Deck Repair

City of Puyallup

ISSUED PERMIT

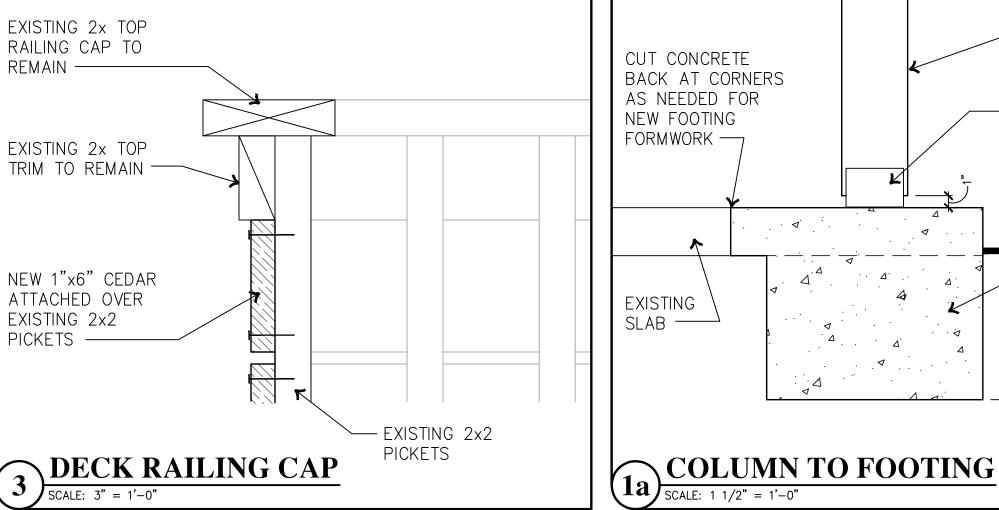
Add a notation on either Sheet A1.0 or A1.1 that contractor shall verify the integrity of balusters prior to the installation of the 1x6 cedar. Establish the parameters of the balusters replacement to include type, grade and nailing pattern.

(Construction Plans, Sheet A1.1)

Provide specifics of the plywood that will be installed which should include plywood thickness, grade and any other specifics that will reflect that the plywood will withstand the dead and live loads of the deck. Identify the non-slip surface that will either be provided on the plywood or will be added to the plywood as part of construction, as notated on sheet A1.0, Owner/Contractor Coordination Notes.

The existing joist spacing should also be considered when selecting the plywood material that will be used. Please provide the existing joist spacing.

(Construction Plans, Sheet A1.1)

Updated all details and notes as needed to reflect the requested information.

1a A1.1

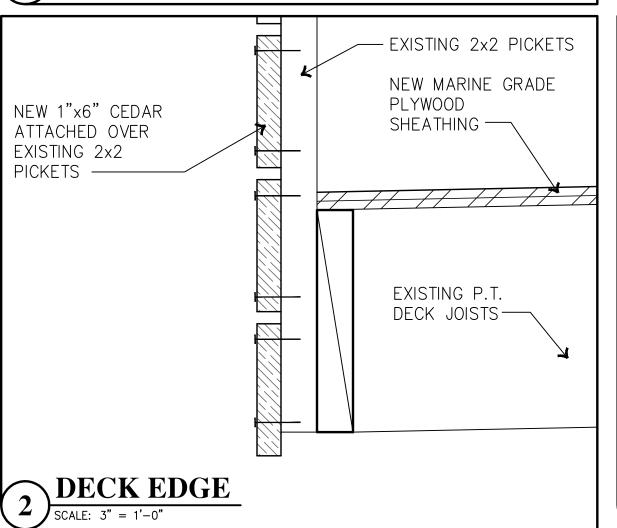
Detail the connection between the existing and proposed

(Construction Plans, Sheet A1.1, Detail 1a)

$\begin{pmatrix} 1 \\ A1.1 \end{pmatrix}$

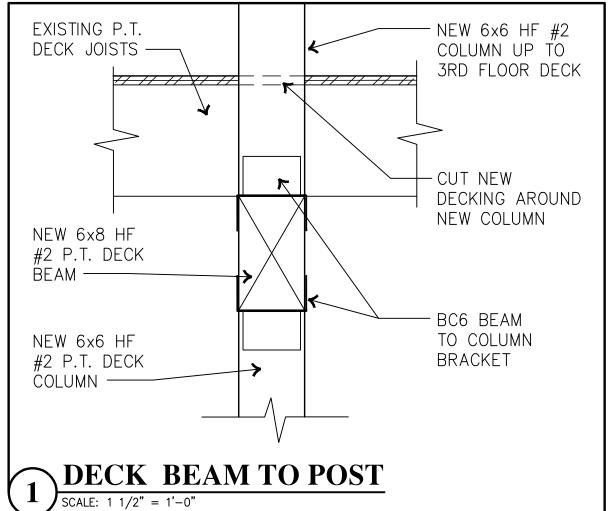
Deck joists appear to be sloped to drain off of the cantilevered side of each deck based upon details 1 and 2. Detail 2 shows the installation of the 1x6 cedar board over the existing 2x2 balusters. detail or notate how the 1x6 cedar will be installed to prevent drainage and water accumulation on the deck surface.

(Construction Plans, Sheet
